OVERALL FLOOR PLANS - BLDGS.; V, W

REDWOOD THE HARRISON PHASE IV

Willowood Left PVC - 1A2.10L - 1A2.11L - A2.12R

PREFAB WILLOWWOOD MODEL

1 WILLOWOOD MID - LEFT PLAN
SCALE: 1/4" = 1'-0"

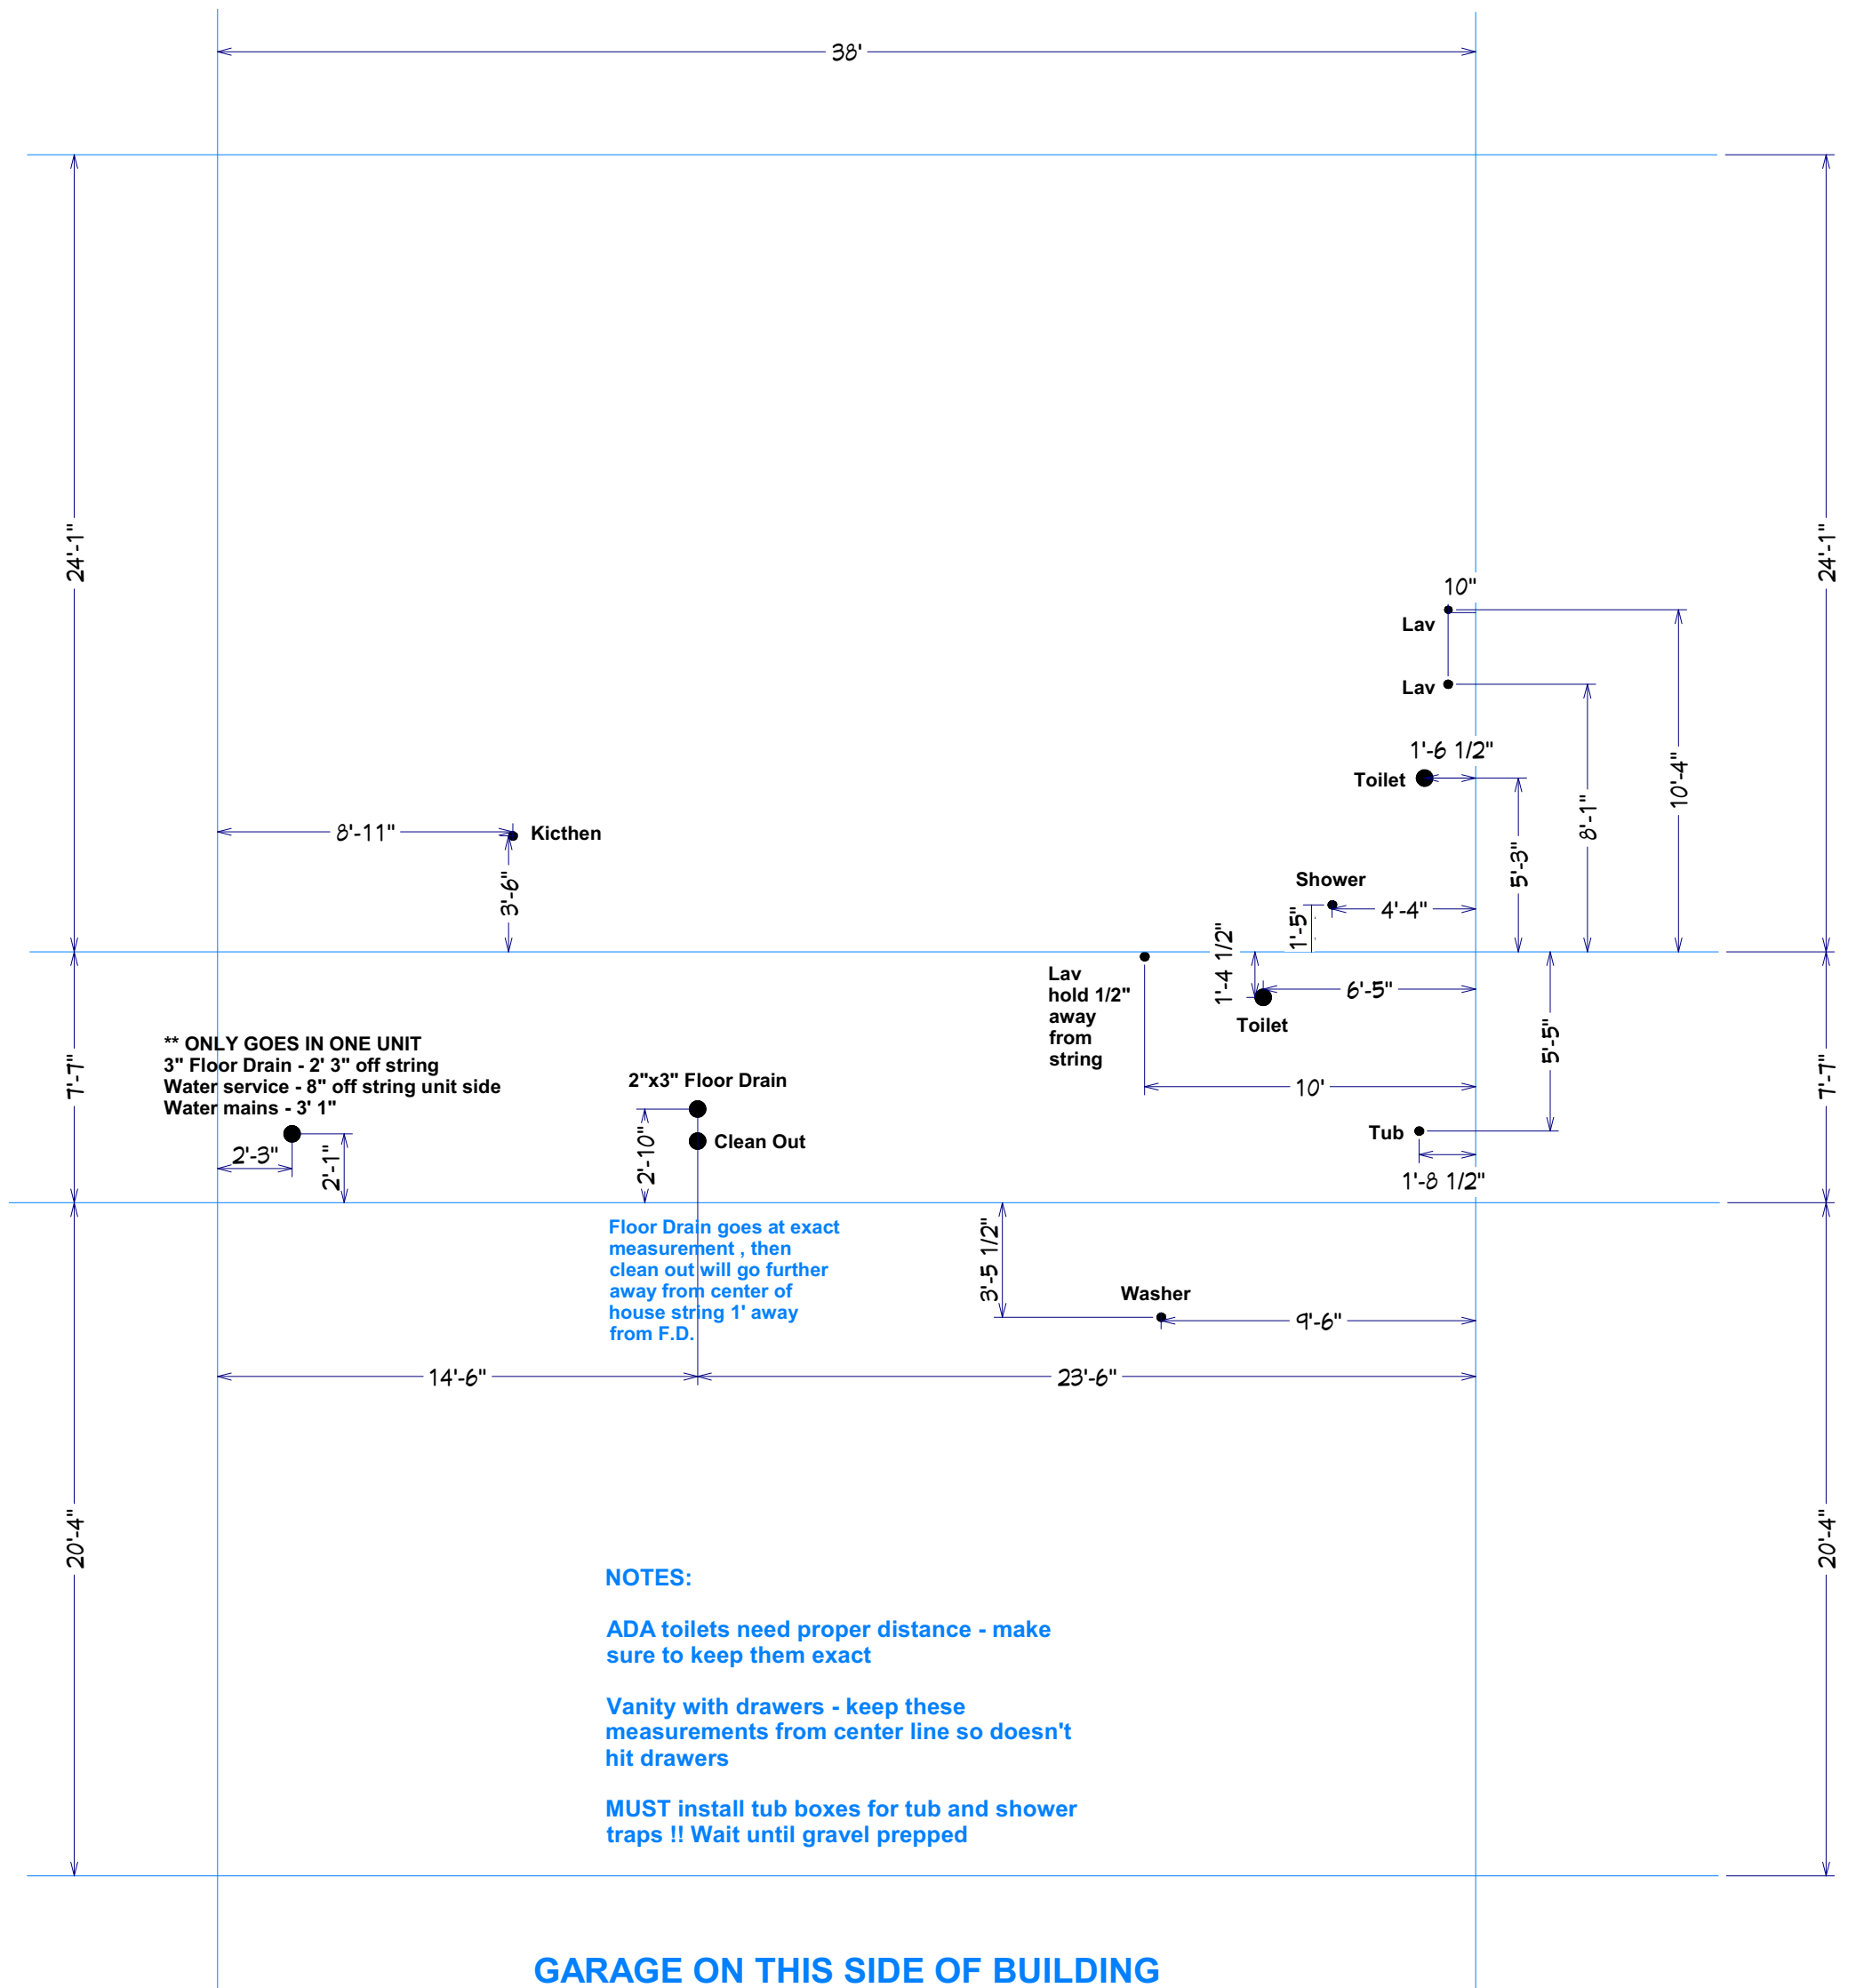
NOTES:
 ADA toilets need proper distance - make sure to keep them exact
 Vanity with drawers - keep these measurements from center line so doesn't hit drawers
 MUST install tub boxes for tub and shower traps !! Wait until gravel prepped

Willowood Left WATER - 1A2.10L - 1A2.11L - A2.12R

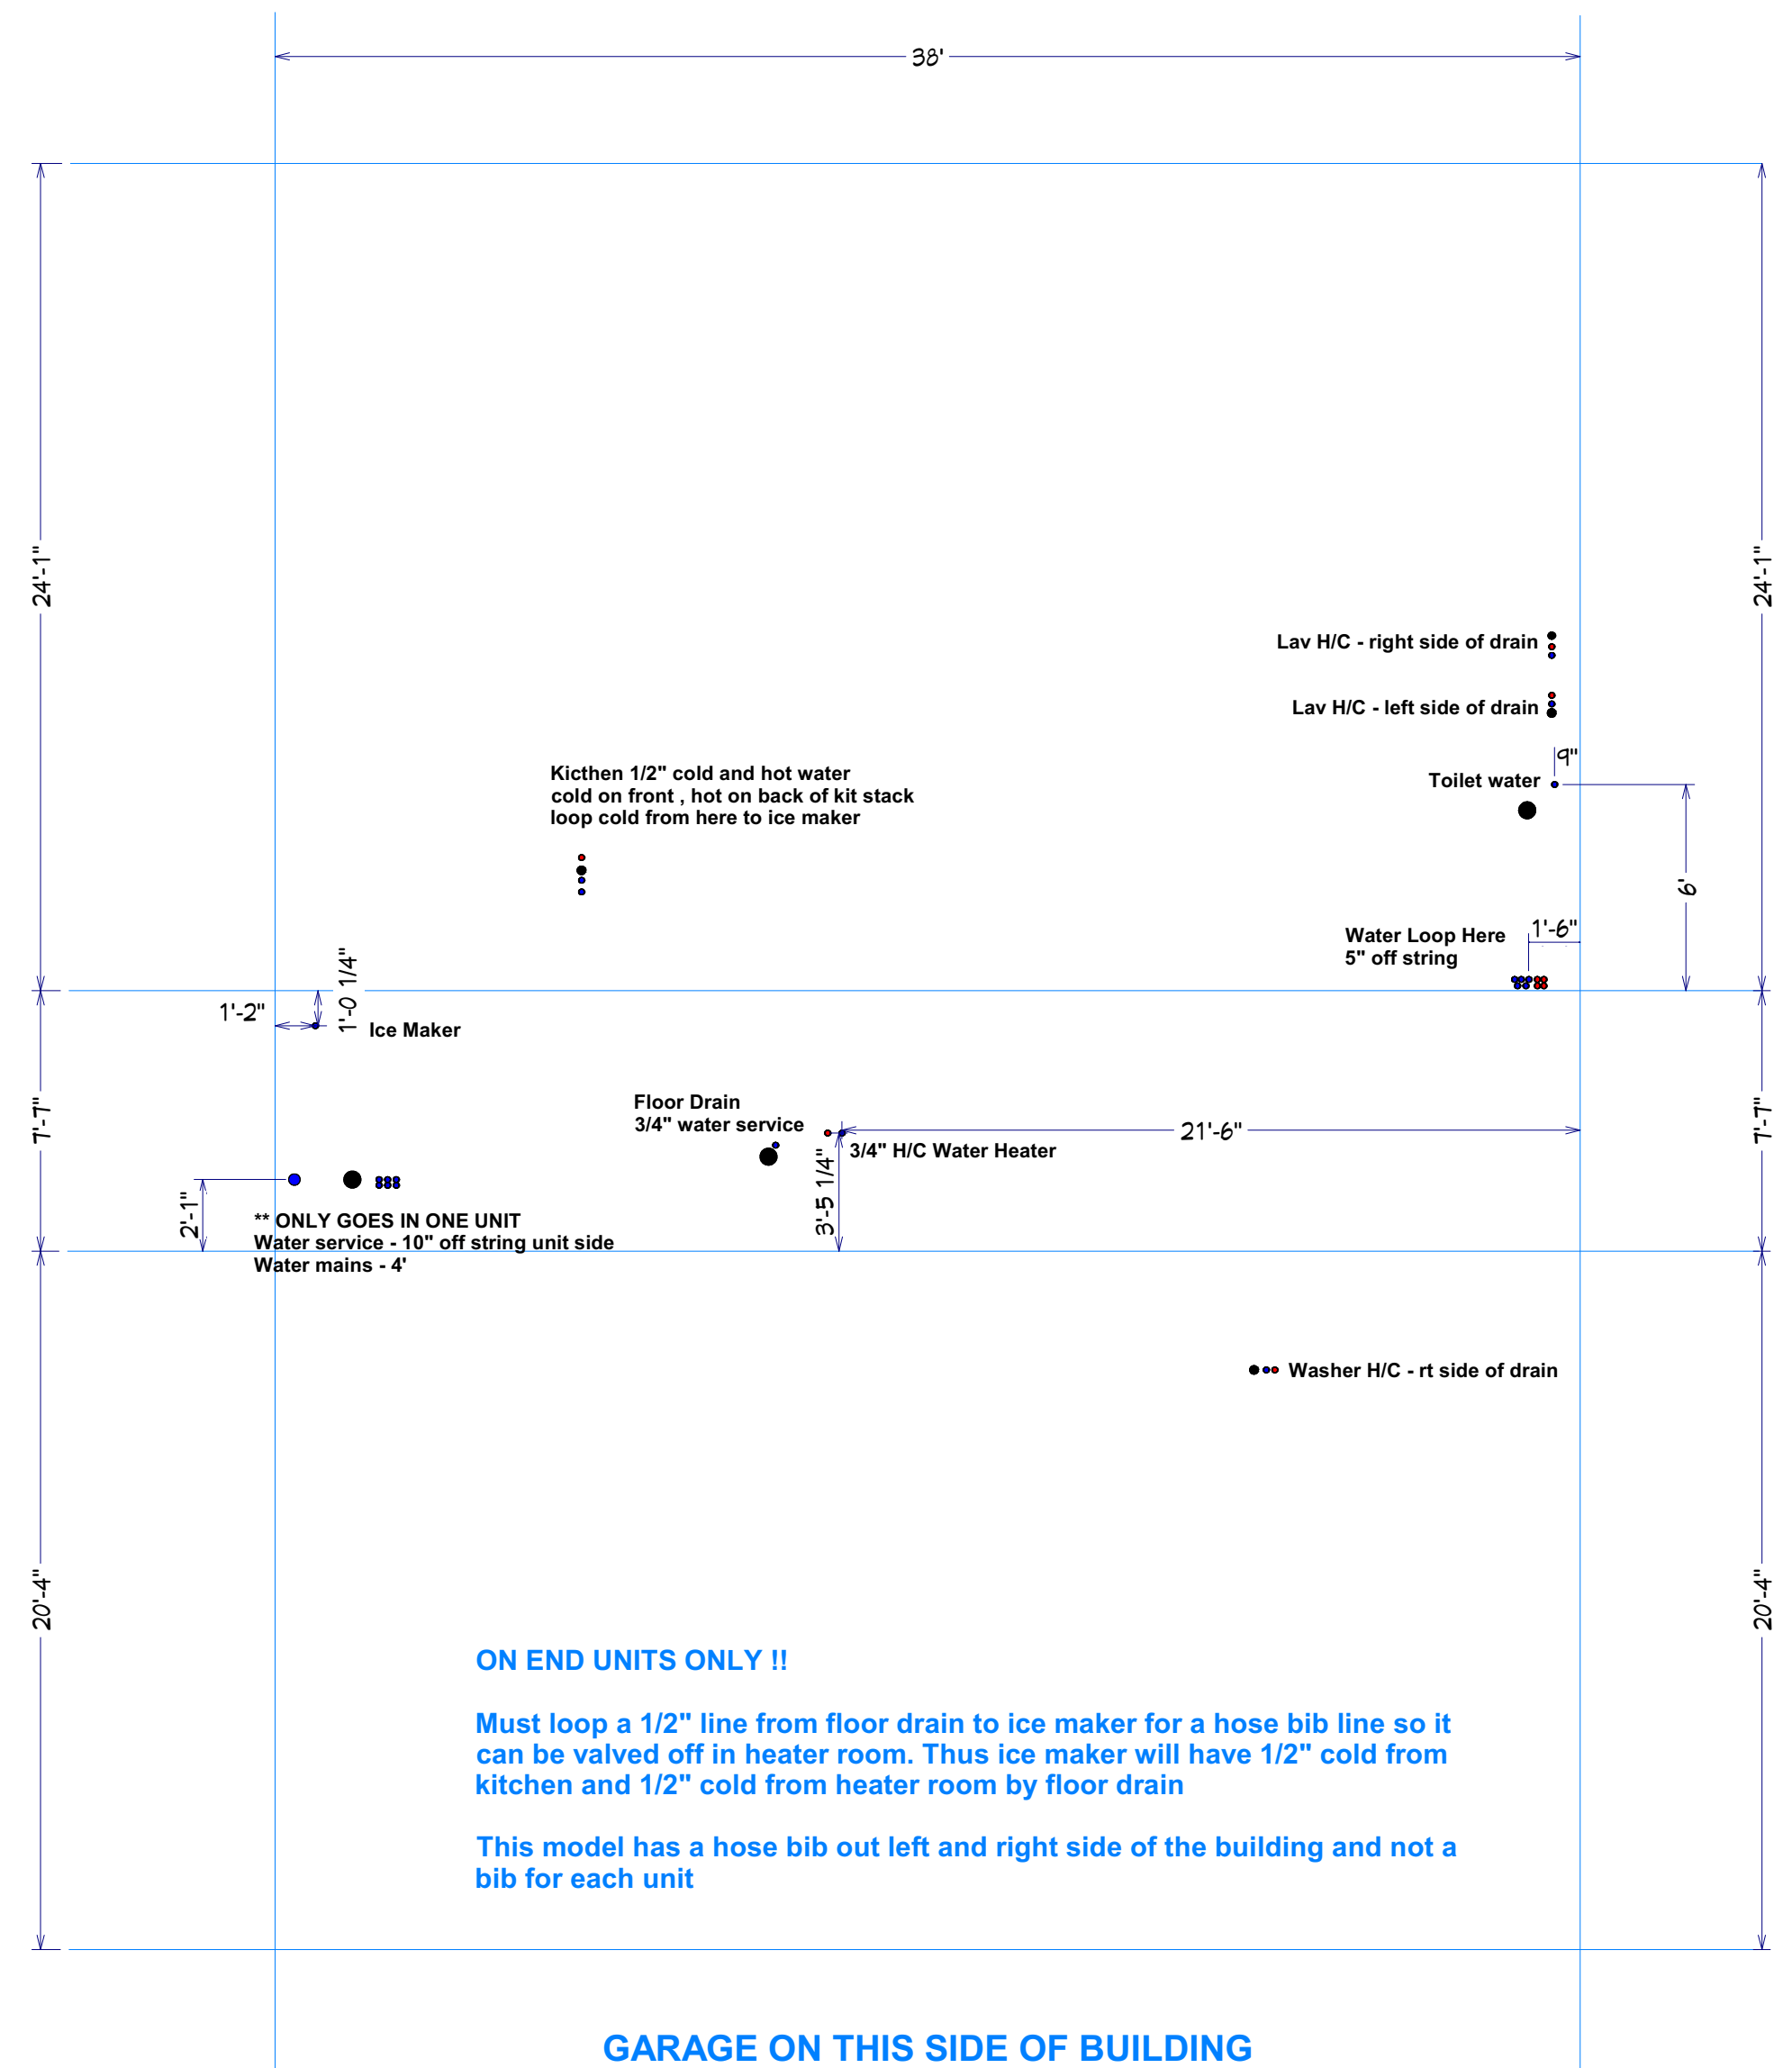
ON END UNITS ONLY !!

Must loop a 1/2" line from floor drain to ice maker for a hose bib line so it can be valved off in heater room. Thus ice maker will have 1/2" cold from kitchen and 1/2" cold from heater room by floor drain

This model has a hose bib out left and right side of the building and not a bib for each unit

1 WILLOWOOD MID - RIGHT PLAN
SCALE: 1/4" = 1'-0"

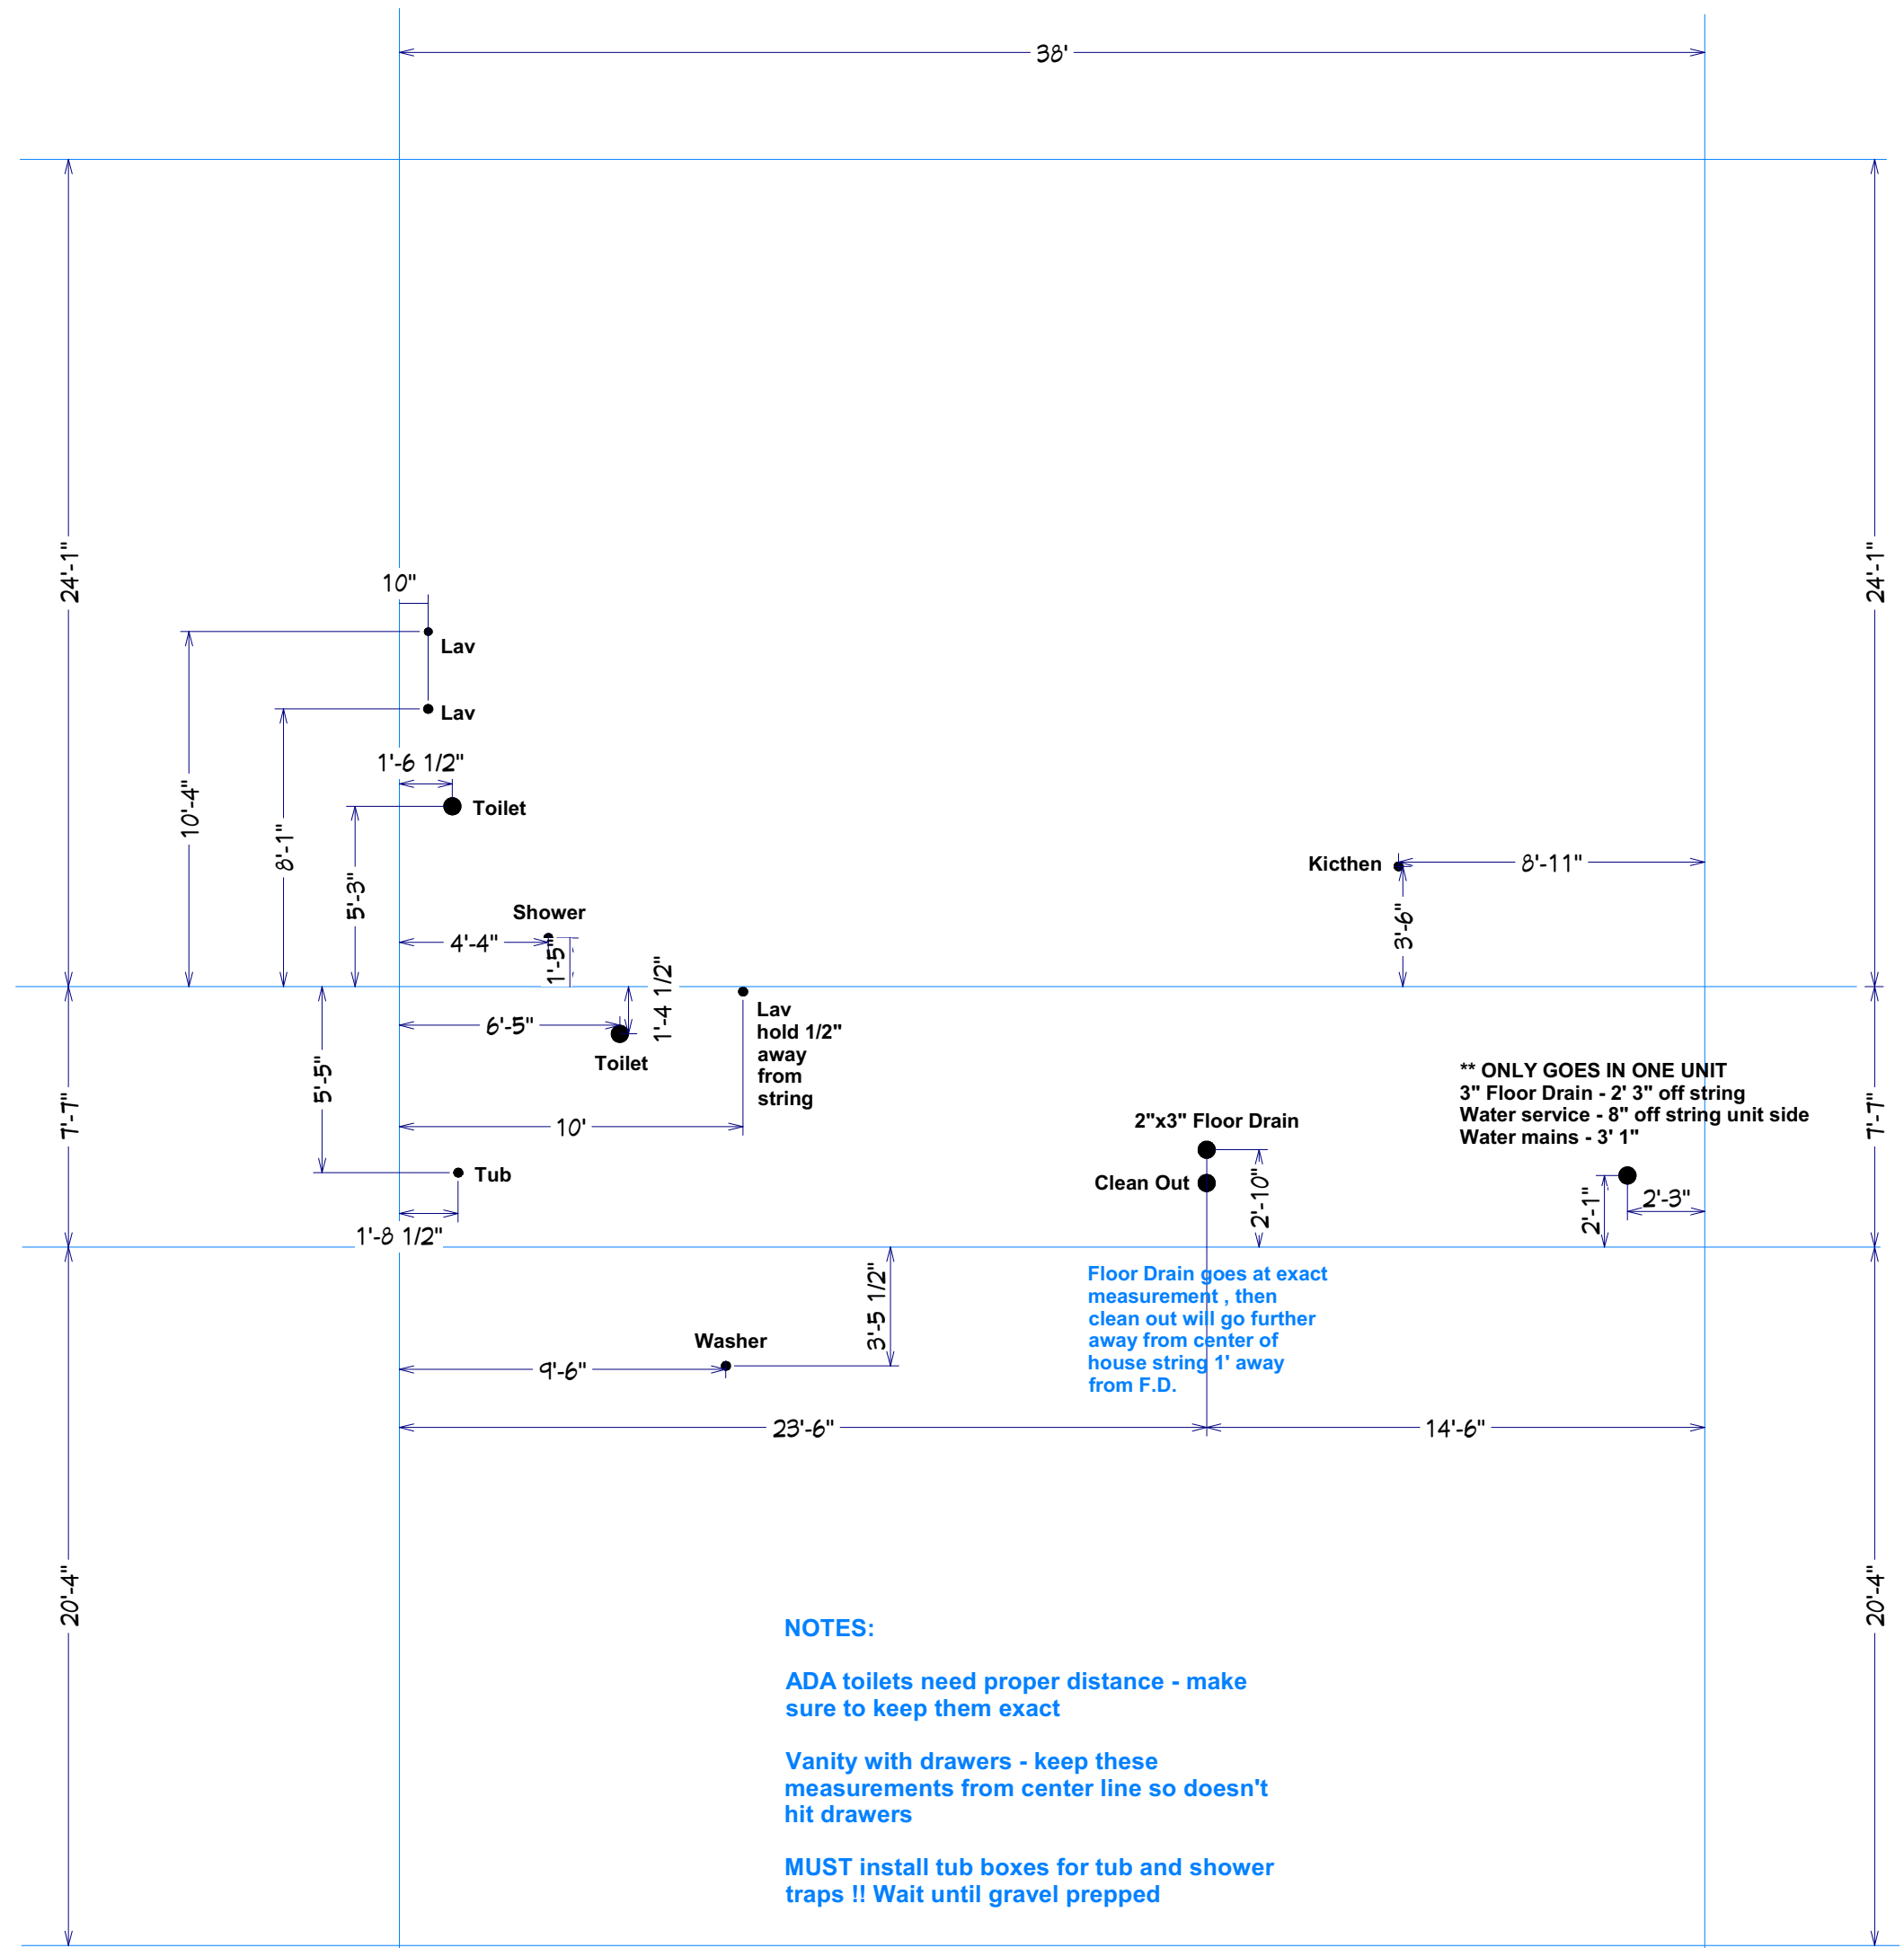
- NOTES:**
- ADA toilets need proper distance - make sure to keep them exact
 - Vanity with drawers - keep these measurements from center line so doesn't hit drawers
 - MUST install tub boxes for tub and shower traps !! Wait until gravel prepped
